## NEW SPL HALF ROUND BEARING RETAINER BOLTS

### SERVICE/TECHNICAL

DATE: 26/7/2011

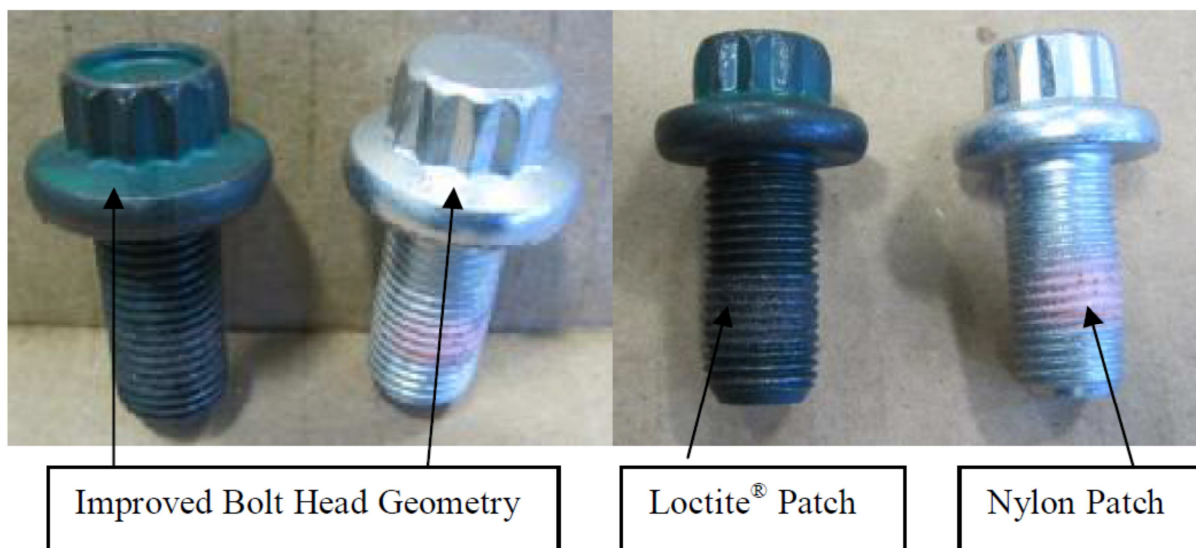
The current SPL170 and SPL250 series bearing retainer and U-Joint kits contain bolt part number 5007417 which is currently green in color with a Loctite patch. The new bolt will retain the same part number but is now silver in color with a pink nylon patch.

The features and benefits of this revision level change are improved bolt head geometry for better socket engagement (Picture on the left)  
Nylon patch retention feature (Picture on the right)
